Hagshaw Energy Cluster – Western Expansion | Phase 1

Gatecheck 1 Report

Client:	3R Energy
Project/Proposal No:	4188
Version:	3.0
Date:	2024-10-30

Figure 3
Proposed Abnormal Load Route Options

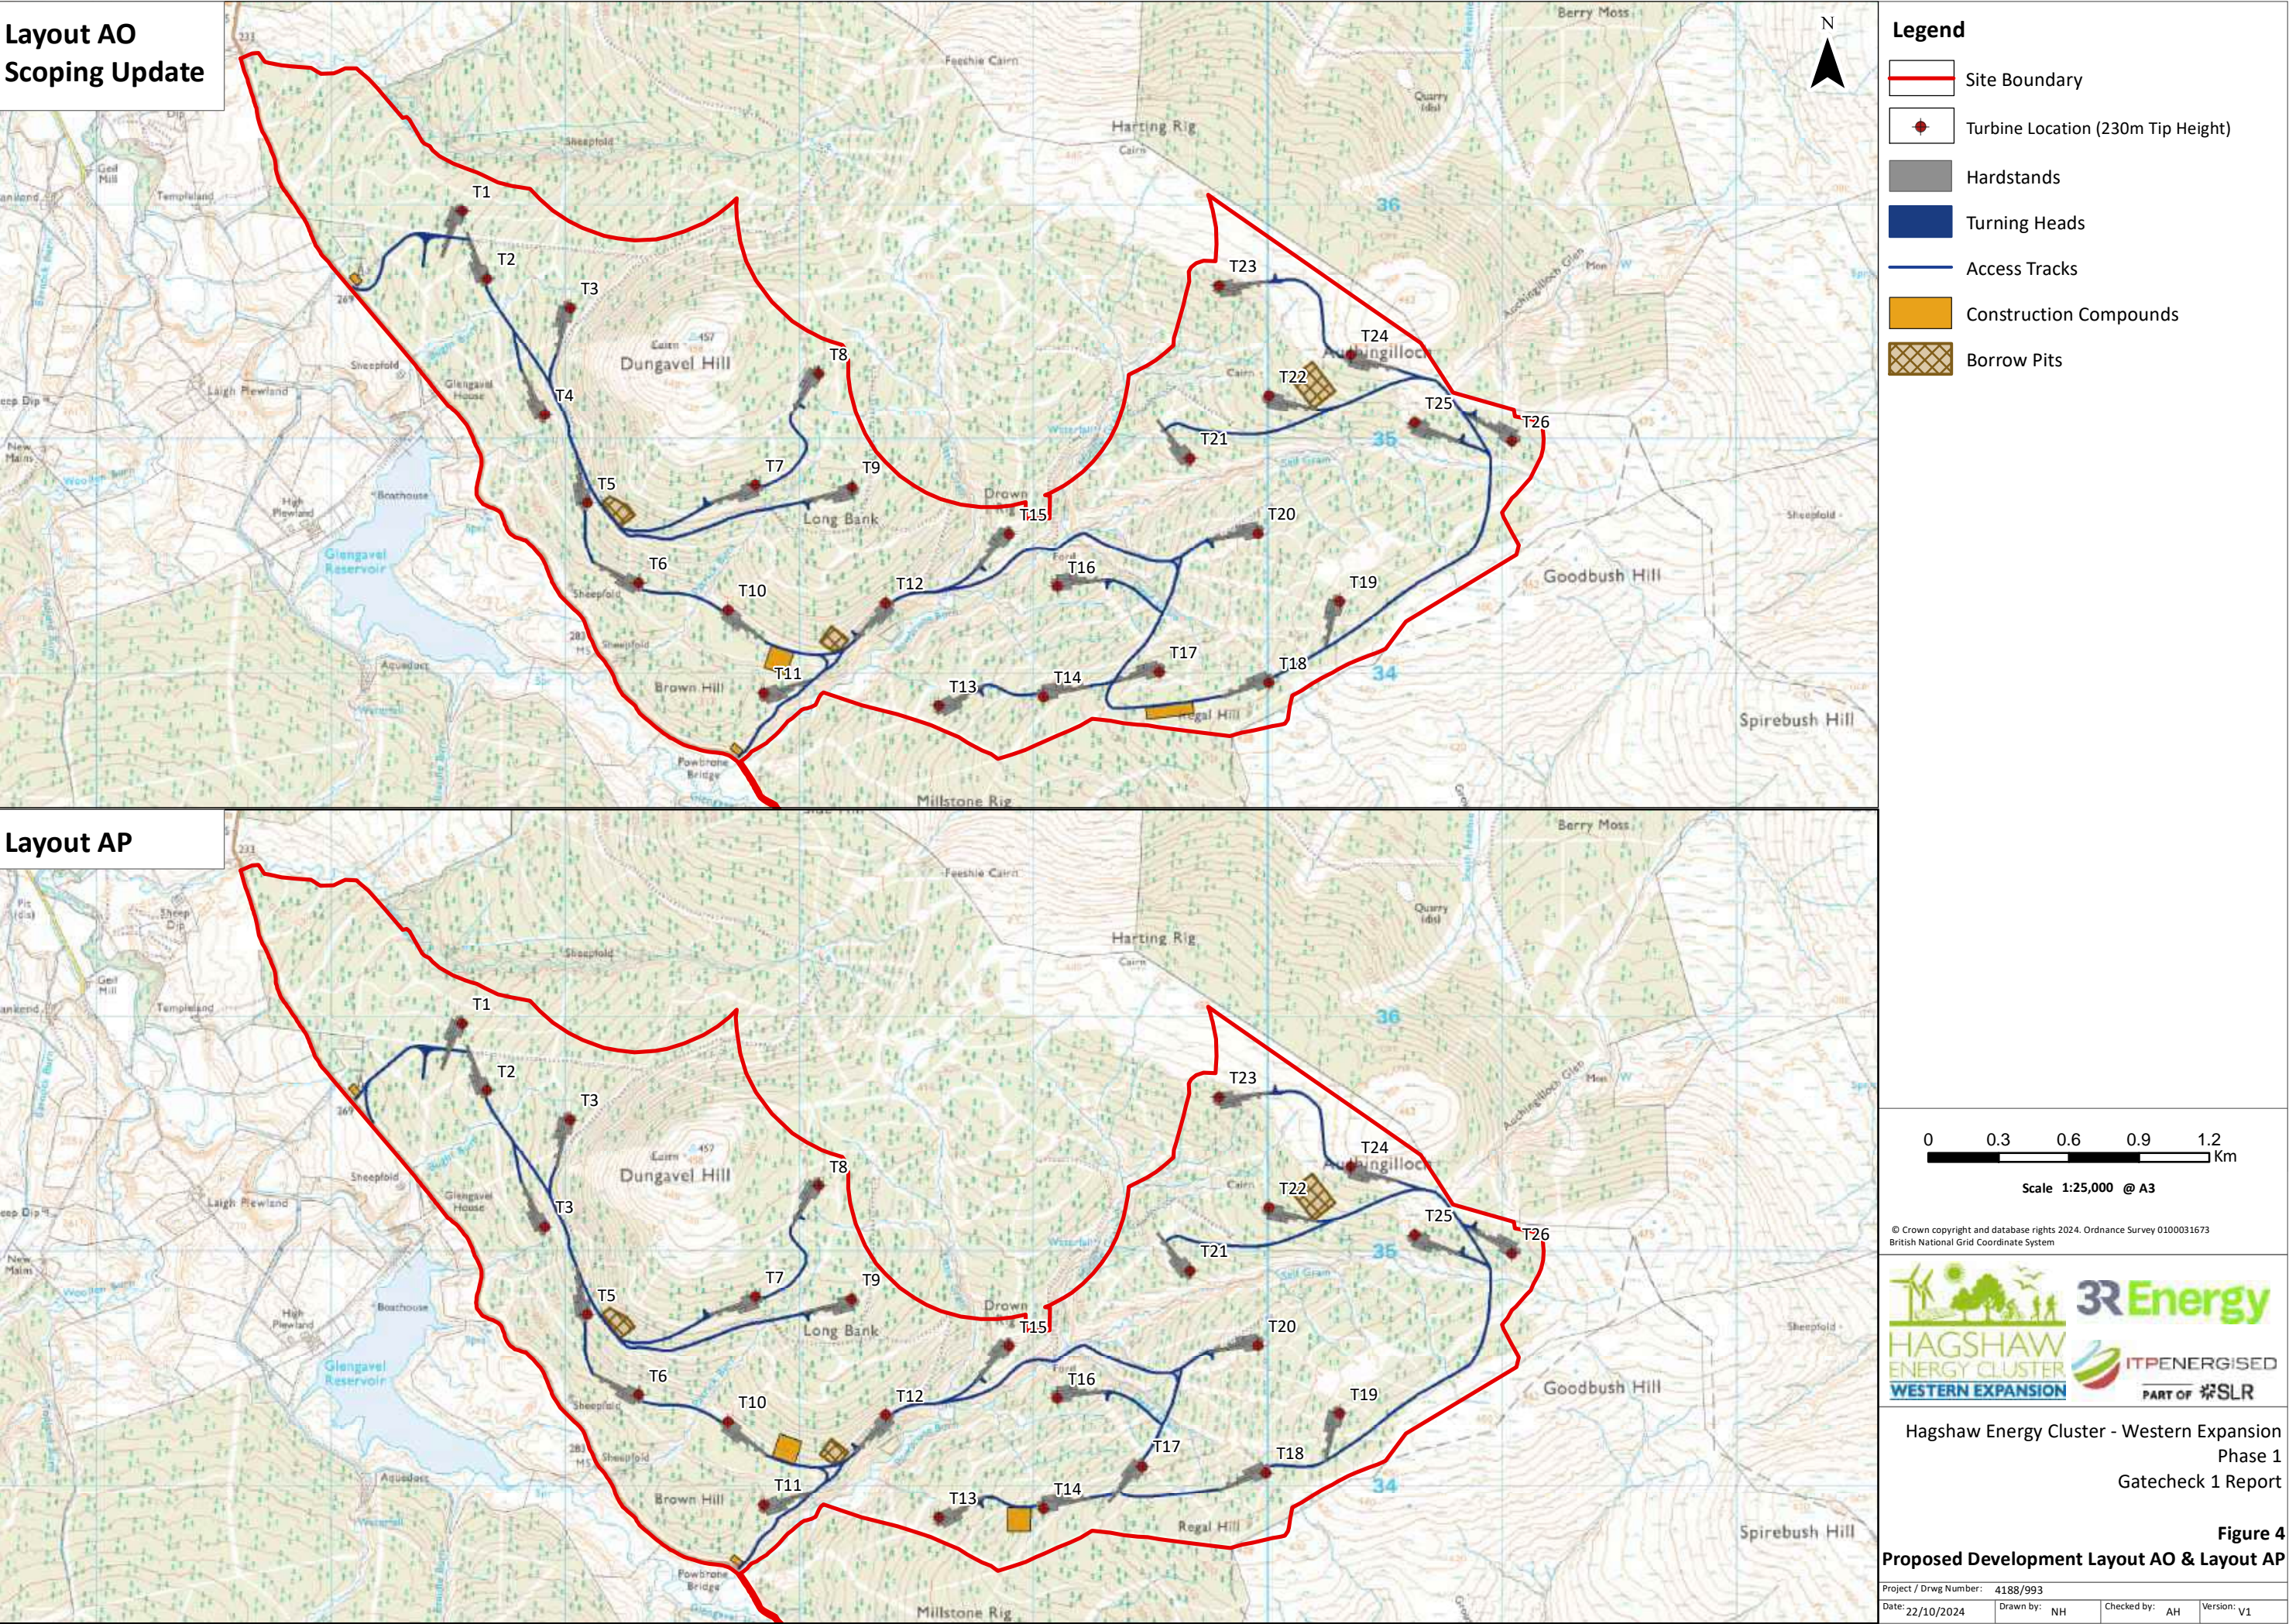
SLC	The B745 would not be accepted for use under any circumstances due to its condition and geometry; in some areas it is effectively single track. As such the B745 would need to be excluded from any potential 'Agreed Route'.	It is not proposed to utilise the B745 for any construction traffic.	N/A
	The Transport Assessment (TA) should include the following: <ul style="list-style-type: none"> ➤ Delivery route plans to be included in the EIA report for abnormal loads from the M74 to each development area. Routes for HGV movements should also be detailed. This will eventually be used to develop an 	Noted. The transport assessment will include these points and will be presented in Chapter 11 Traffic and Transport of the EIA Report.	Further consultation will be undertaken with SLC and EAC on the scope of the transport assessment. Two access routes for abnormal loads will be assessed within the EIA as shown on Figure 3 .

Scoping Comment	Response to Consultee	Further EIA Consultation
EAC	The Planning Authority would advise that the traffic assessment should be based on a worst-case scenario which assumes 100% of construction materials such as stone requiring to be imported to site. Any expected reduction in stone importation due to the use of borrow pits can be reported within the EIA Report, along with the consequent effect this would have on traffic volumes.	Noted. This will be covered in Chapter 11 Traffic and Transport of the EIA Report.	N/A
	The EIA Report should identify potential sources of materials (e.g. stone quarries) if these are off-site and consider the impacts of those routes to site, including communities along those routes. Such assessment should also include cumulative impacts with other developments.	Noted. This will be covered in Chapter 11 Traffic and Transport of the EIA Report.	N/A
	The EIA Report should detail the port of entry and the delivery route for turbines and components to site. Transport Scotland may provide advice in respect of the trunk road network, whilst the Applicant is also encouraged to discuss traffic matters with the Council's Ayrshire Roads Alliance.	Noted. This will be covered in Chapter 11 Traffic and Transport of the EIA Report.	Further consultation will be undertaken with SLC and EAC on the scope of the transport assessment. Two access routes for abnormal loads will be assessed within the EIA as shown on Figure 3 .

Scoping Comment	Response to Consultee	Further EIA Consultation
	whether any structures are affected by the route (james.gray@southlanarkshire.gov.uk).		
	A separate Scoping Agreement shall be required between SLC Roads and Traffic Consultant before any survey work is undertaken for the Transport Assessment. This will include agreement on survey locations, threshold levels, committed developments, sensitivity tests for nearby live windfarm sites etc., and traffic growth rates.	Traffic count and speed surveys were undertaken in June 2023. No further surveys are proposed.	N/A
	If the B743 is being accepted as an access for cars and small, transit sized vans, the proposed access onto the B743, which is subject to the national speed limit, should benefit from a 4.5metre by 215 metre visibility splay in both directions. It is acknowledged that vehicle speeds may be lower than the signed speed limit given the local characteristics of the road, which may allow for a reduction in the visibility splay requirements. The Council would, therefore, be willing to consider a reduction in the visibility splay where the applicant can demonstrate, by means of a continuous 7-day vehicle speed survey, that the 85th percentile speed, that is the speed at or below which 85% of motorists consider it safe to travel at with regards to the prevailing road conditions, is lower than the signed speed limit in force on this section of road.	The B743 is proposed for abnormal load access and construction vehicles. Visibility splays are to be investigated further.	Further consultation will be undertaken with SLC and EAC on the scope of the transport assessment. Two access routes for abnormal loads will be assessed within the EIA as shown on Figure 3 .

Figure 1
Cumulative Zone of Theoretical Visibility to 35 km with Viewpoints

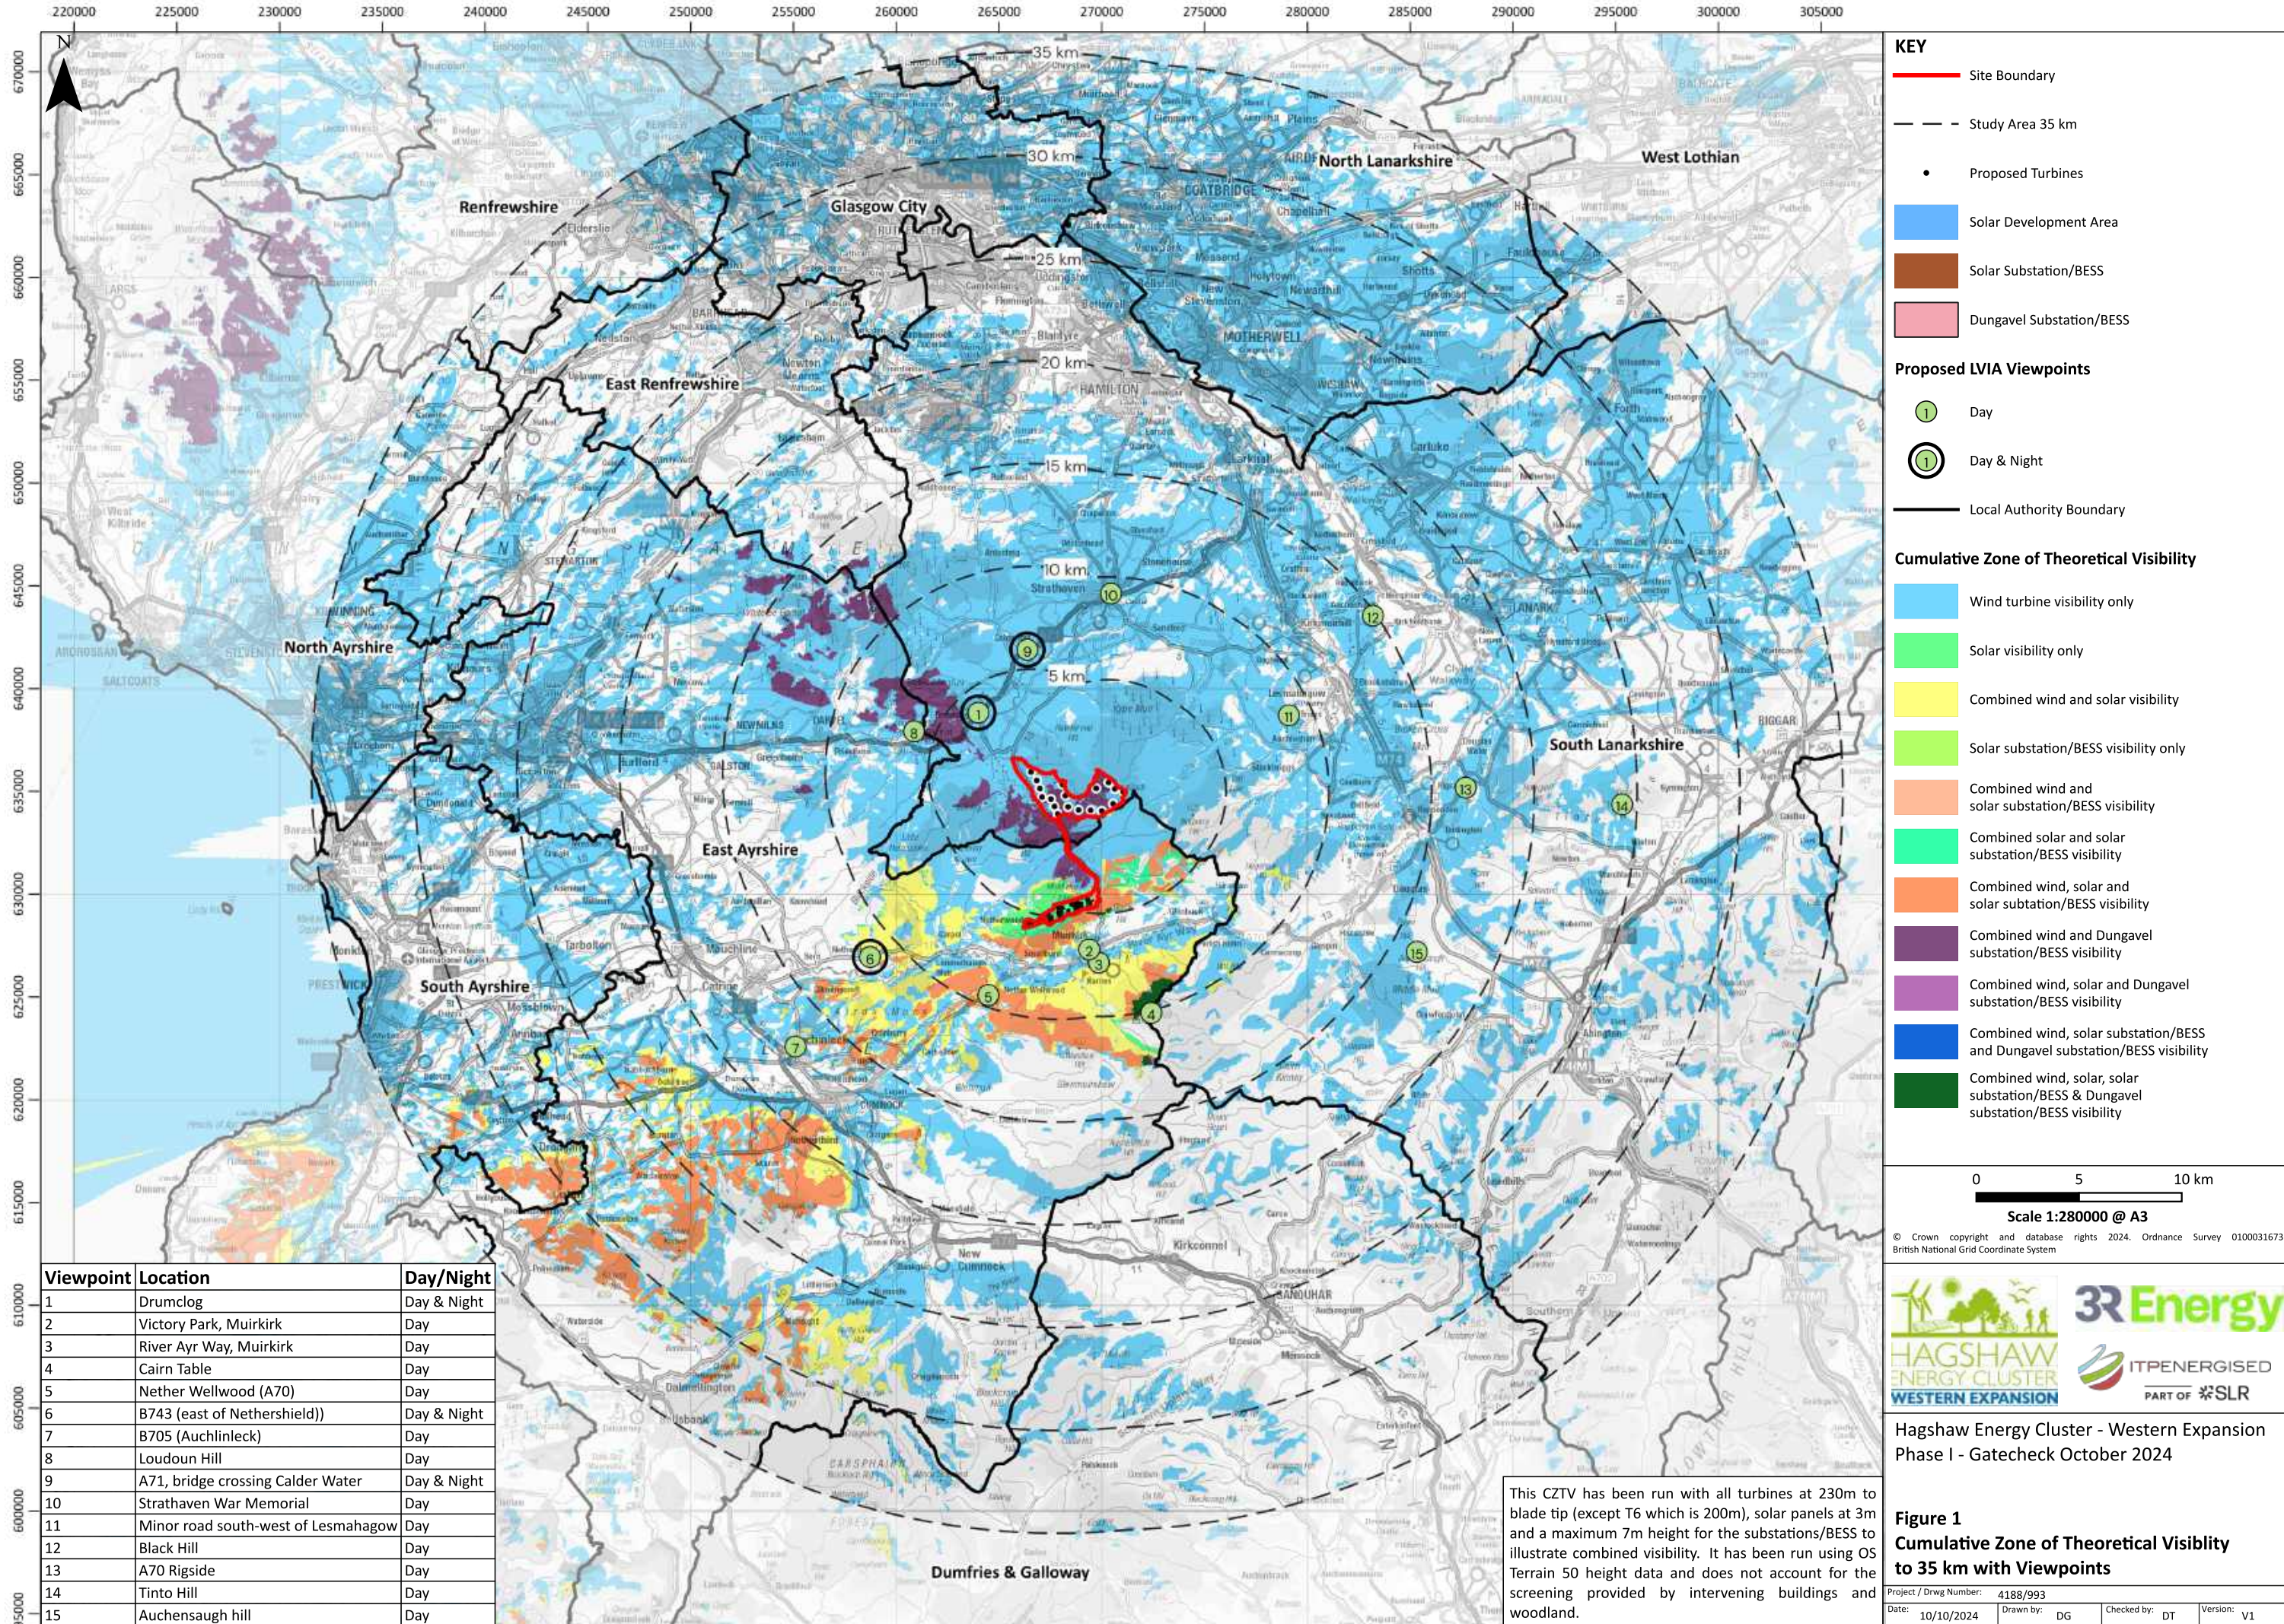
The Planning Authority would request a night time viewpoint within the East Ayrshire district to coincide with visibility of turbines. Based on the ZTV (Figure 5.1) this might be one of either VP5, VP6 or VP8, depending on the extent of visibility of lighting.	Viewpoint 6 – B743 (east of Nethershield) will be included within the LVIA as a night-time visual viewpoint.	N/A
	It would be expected that every effort is made to reduce the impacts of visible aviation lighting as far as possible, particularly given the substantial increase in cumulative pressure/impacts from visible aviation lighting associated with large numbers of wind farm proposals / consents for turbines over 150m in height.	Noted. The current proposed lighting design is shown in Figure 8 .	N/A
	The Planning Authority would expect that RVA impacts are assessed for both daytime impacts and night time impacts	Noted. This will be included within the RVA Assessment.	N/A

Consultee	Scoping Comment	Response to Consultee	Further EIA Consultation
	Night-time visualisations are proposed from representative viewpoints 2 and 5. We advise inclusion of an additional night-time visualisation from Loudoun Hill (proposed viewpoint 8) given the popularity of this viewpoint and its location to the north-west of the proposal.	<p>We propose Nighttime visuals will be produced from LVIA:</p> <ul style="list-style-type: none"> ➤ Viewpoint 1 – Drumclog ➤ Viewpoint 6 – B743 (east of Nethershead) ➤ Viewpoint 9 – A71, bridge crossing Calder Water <p>It is not proposed to include Loudoun Hill as a night-time visualisation as there would be a limited number of receptors who would be present at the summit after dark. As this viewpoint is not within 5 km of a proposed lit turbine it would benefit from reduced visibility from the built in lighting mitigation.</p>	The viewpoints proposed for LVIA are outlined in Appendix 1 . We would look for agreement of these viewpoints with SLC, EAC, and NS.

Consultee	Scoping Comment	Response to Consultee	Further EIA Consultation
	The Planning Authority does not agree that night time landscape effects can be scoped out as aviation lighting has an impact on the landscape character in addition to visual impacts.	<p>A night time visual assessment will be included within Chater 5 Landscape and Visual of the EIA Report.</p> <p>Night-time visuals will be produced from LVIA:</p> <ul style="list-style-type: none"> ➤ Viewpoint 1 – Drumclog ➤ Viewpoint 6 – B743 (east of Nethershield) ➤ Viewpoint 9 – A71, bridge crossing Calder Water 	<p>The current proposed lighting design is shown in Figure 8.</p> <p>The viewpoints proposed for LVIA are outlined in Appendix 1. We would look for agreement of these viewpoints with SLC, EAC, and NS.</p>
	As the design evolves, it would be useful to agree a final set of viewpoints with the Planning Authority and relevant surrounding authorities and NatureScot at that time at the design freeze to ensure the LVIA / RVAA is based on an agreed set of viewpoints at that point.	Noted.	The viewpoints proposed for LVIA are outlined in Appendix 1 . We would look for agreement of these viewpoints with SLC, EAC, and NS.
